REV.
E

AS3480™

RATIONALE

(R) NUT, SELF-LOCKING, PLATE, ONE LUG,
REDUCED RIVET SPACING, LOW HEIGHT, UNS S66286,
CLASS: 125 KSI/800 °F

FIGURE 1

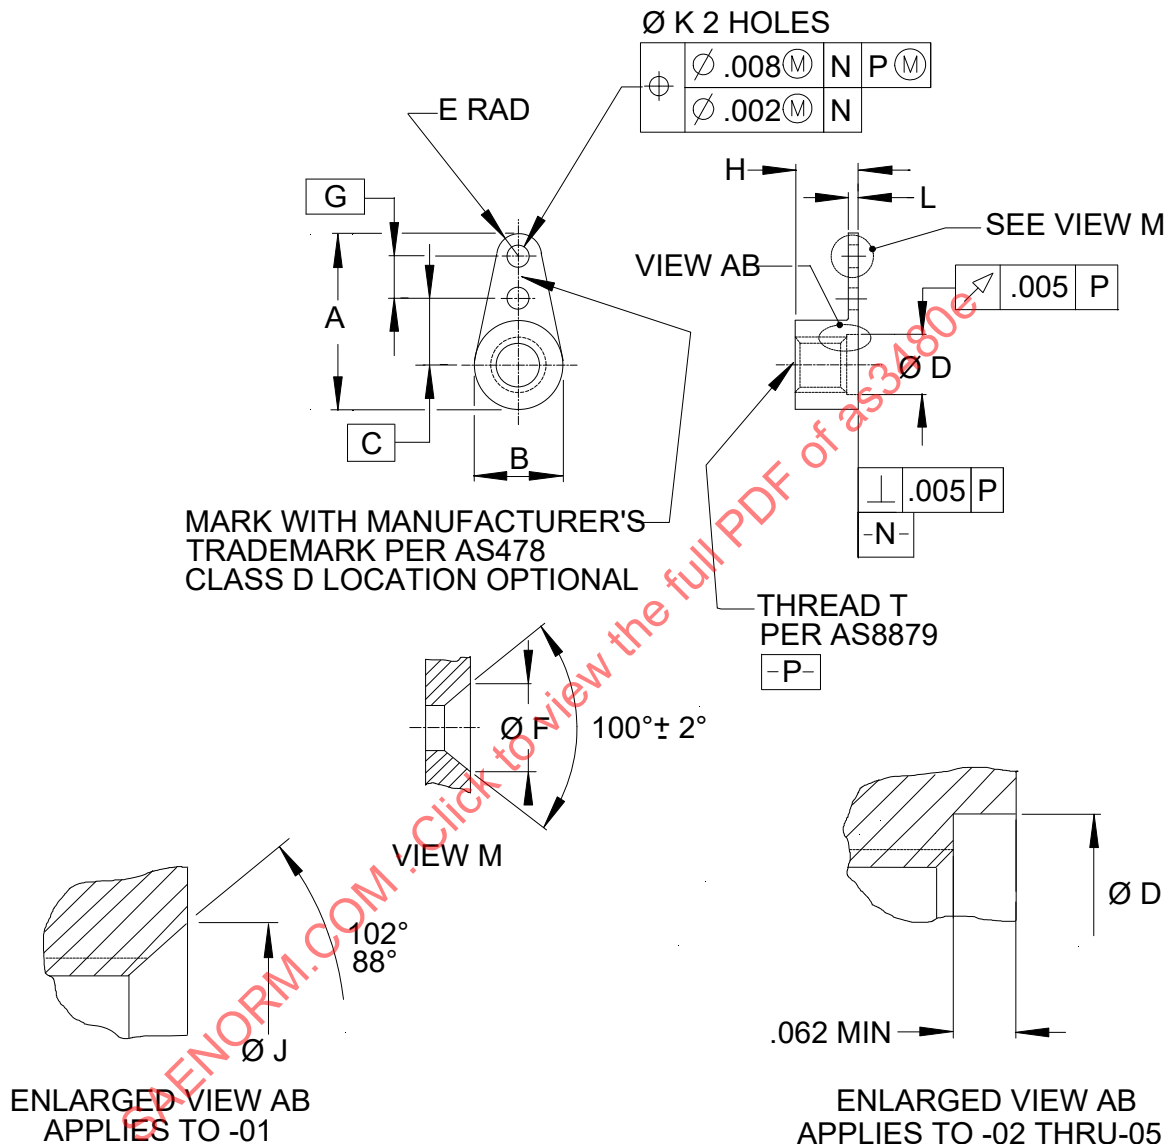
FIGURE 1 REDRAWN RESTRUCTURE NOTES 1, 2, AND 3 FOR CLARITY, SILVER PLATE NOTE CHANGED TO AS2411 FROM AS2410 AND ADD EXCEPTION FOR RECRYSTALLIZED MICROSTRUCTURE, ADD NEW NOTE FOR DISPOSITION OF EXISTING INVENTORY, GENERAL EDITORIAL AND FORMAT CHANGES.
